N5181B-06

Information Only Service Note

N5181B X-Series MXG Analog Signal Generator

The Problem – Self-test #104 failure if replacement A3 RF Assembly N5180-60296 with Hardware ID 0008 is not upgraded to the minimum FW B.01.96.

Figure 1 - Multiple self-test failures

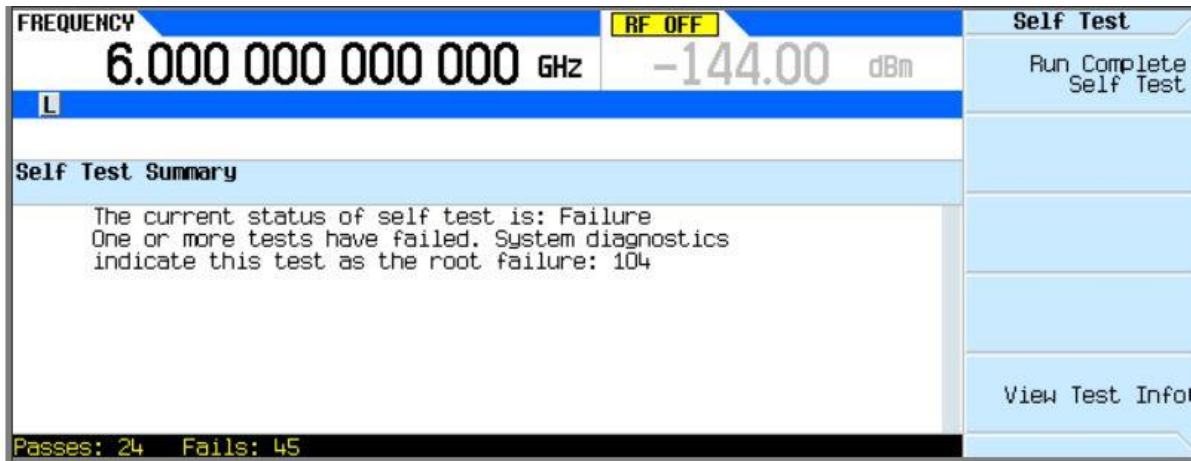
The A3 RF assemblies were enhanced to support a new 12bit ADC for assurance of supply (AOS). Replacement of the A3 RF Assembly, N5180-60296 with Hardware ID 0008 will require minimum FW B.01.96 for it to operate properly. Multiple self-test failures can be observed after completing the self-test, as shown in Figure 1.

Upgrade the instrument firmware to B.01.96. Go to http://www.keysight.com/find/mxg_firmware to download the instrument firmware.

Once the firmware successfully upgraded, verify that the self-test is passing on the instrument.

Figure 2 - Installed Board Information Screen

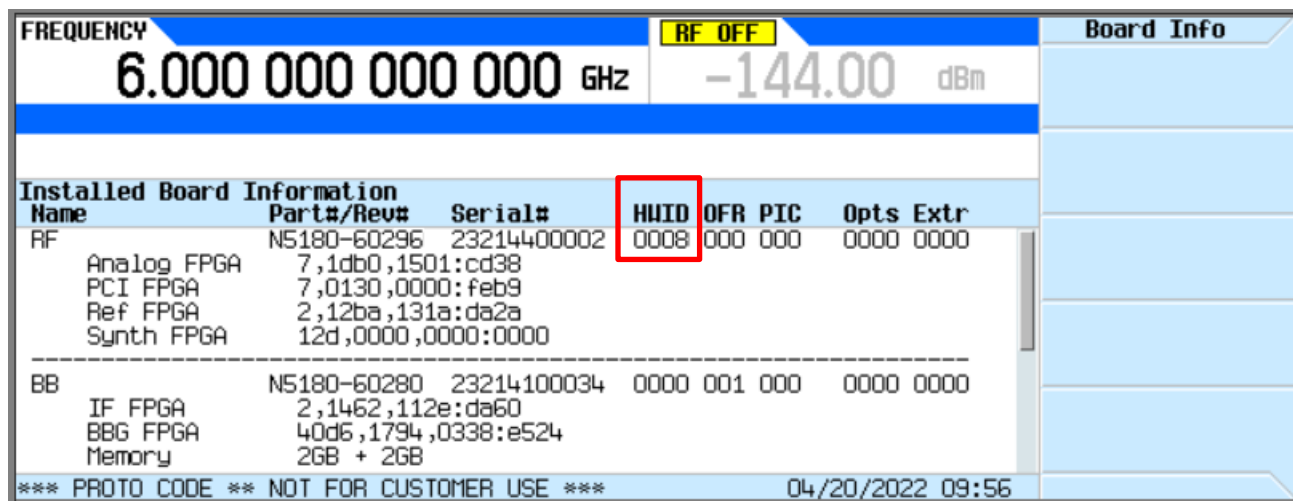
First, check that the RF assembly is with hardware ID 0008. This can be found on the Utility, Instrument Info, Installed Board Info screen of the instrument, as shown in Figure 2.
